September 11, 2025

PROJECT NAME: HIS HOUSE FOR HER

PROJECT NUMBER: 2025040018

APPLICATION: MAJOR SITE PLAN #32698

L-1

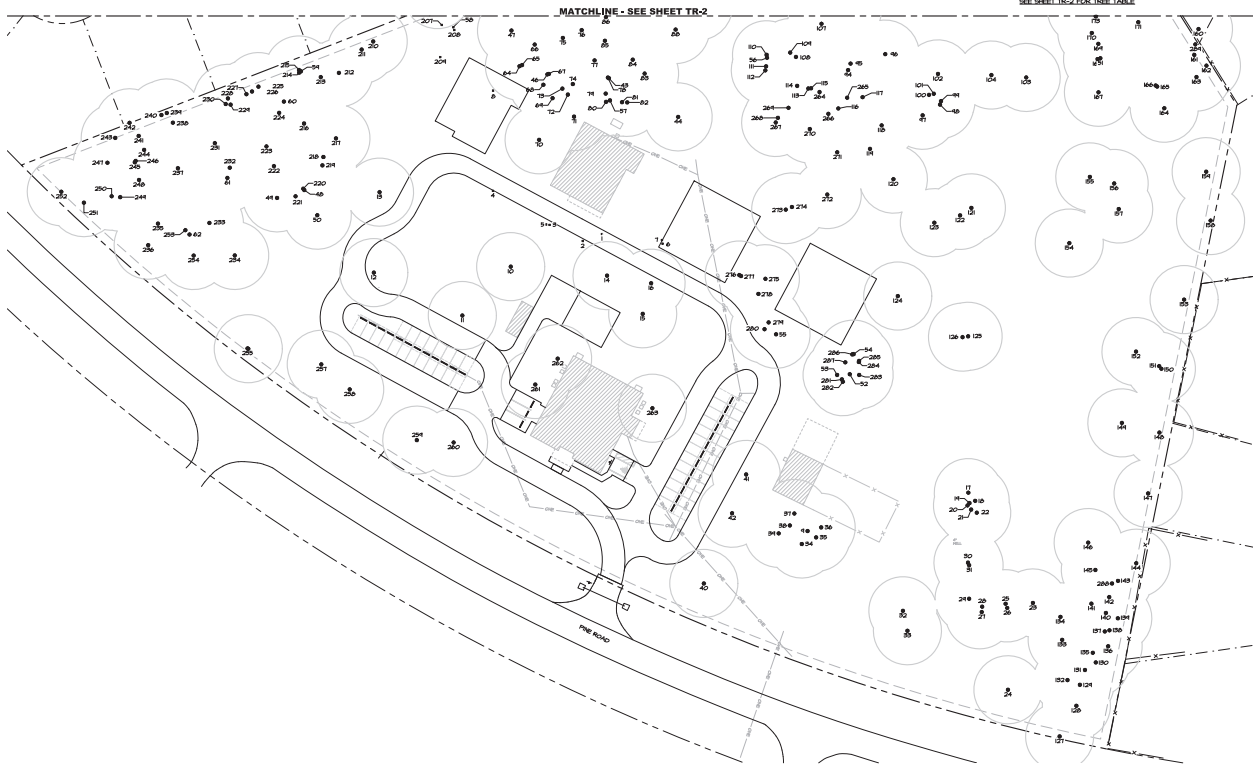
- 20 DEPARTMENT: LSCAPE - LANDSCAPE DESIGN AND IRRIGATION
REVIEW ITEM: 6.8.9 - Service and equipment areas
STATUS OF REVIEW: INFO
REMARKS: Dwf Walter's viburnum may not achieve the required six feet in three years.

REMARKS: Type C Buffer will be required along Pine Rd. please show on plan

REMARKS: Provide irrigation plan for the buffer along Pine Rd

REMARKS: 7/17 Review: Type C buffer is required by code. Show on the site plan and landscape plan. Any waiver request relating to buffers will be automatically denied during the DRC meeting and sent to the County Commissioners for their consideration.

Reason/Justification for Request (be specific): A waiver is requested to use a Modified Type C Landscape Buffer along Pine Ave due to the existing trees and natural character of this residential frontage. Native plantings are proposed in the gaps between the trees to provide landscape screening and buffering of driveways, parking areas, and structures. Existing, expansive open areas are preserved as is with no screening proposed.

HIS HOUSE FOR HER APARTMENTS
MARION COUNTY, FLORIDA
LANDSCAPE PLAN

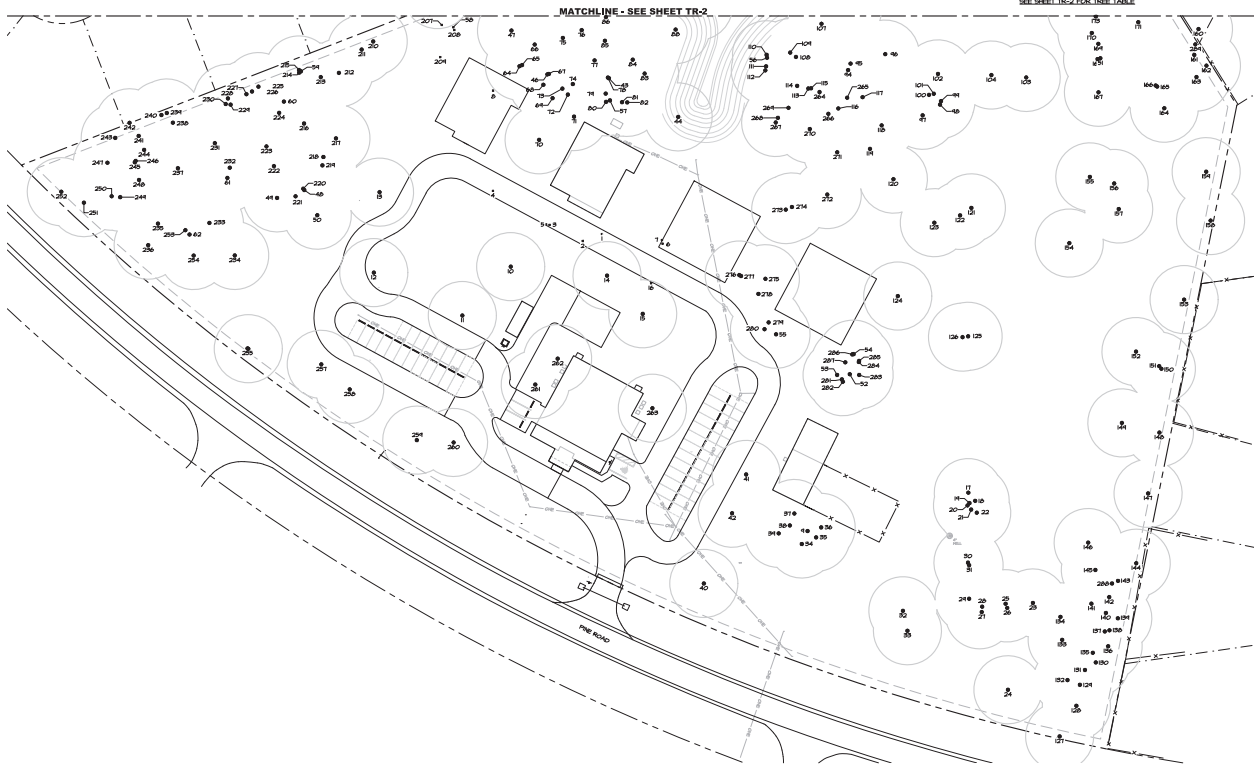
REMARKS: 7/24/25 - SUP Condition #7, as per the SUP conceptual plan, requires that a 30' wide (deep) natural vegetation landscaped buffer zone will be used as the buffers to the north, east, and west. The site plan sheet and landscape sheet must reflect/illustrate this requirement; for illustration, as a limited development area is indicated, but compliance is required, the plan must show the buffer along the boundaries on the more detailed site and landscape plan sheets, but an additional inset diagram must also be provided reflecting/showing that the 30' buffer will be provided around the full extent of the site, consistent with the SUP condition.
